Project	IEEE 802.16 Broadband Wireless Access Working Group < http://ieee802.org/16 >	
Title	802.16h Working Document Structure Reorganization	
Date Submitted	2006-07-10	
Source(s)	Wu Xuyong, Huawei Mariana Goldhamer, Alvarion Grandblaise David, Motorola John Sador, CRC Avi Freedman, Hexagon	Voice:+86 755 28780808 Fax: mailto:wuxuyong@huawei.com
Re:	IEEE 802.16h-06/016 -Second Working Group Review: Working Document for P802.16h (2006-06-05)	
Abstract	The implementation result of contribution C80216h-06_046r1 within ad-hoc group [16h-TOC].	
Purpose	Show to be discussed in [16h-TOC] ad-hoc and will be the output of ad-hoc group after discussion.	
Notice	This document has been prepared to assist IEEE 802.16. It is offered as a basis for discussion and is not binding on the contributing individual(s) or organization(s). The material in this document is subject to change in form and content after further study. The contributor(s) reserve(s) the right to add, amend or withdraw material contained herein.

Draft IEEE Standard for
Local and Metropolitan Area Networks

Amendment for Improved Coexistence Mechanisms for License-Exempt Operation

Figure 219—Illustration of OFDMA frame with multiple zones

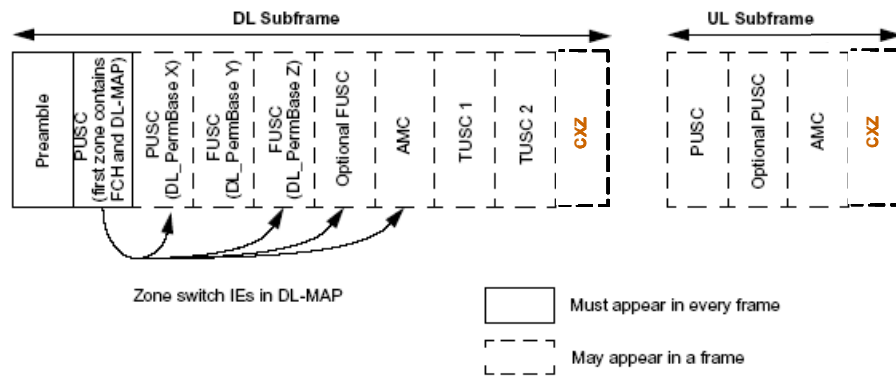
The OFDMA frame may include multiple zones (such as PUSC, FUSC, PUSC with all subchannels, optional FUSC, and AMC, CXZ, TUSC1, and TUSC2), the transition between zones is indicated in the DL-Map by the STC_DL_Zone IE (see 8.4.5.3.4), CXZ_DL_IE (see 8.4.5.3.11), or AAS_DL_IE (see 8.4.5.3.3). No DL-MAP or UL-MAP allocations can span over multiple zones. Figure 219 depicts the OFDMA frame with multiple zones.

[change figure 219 as following:]
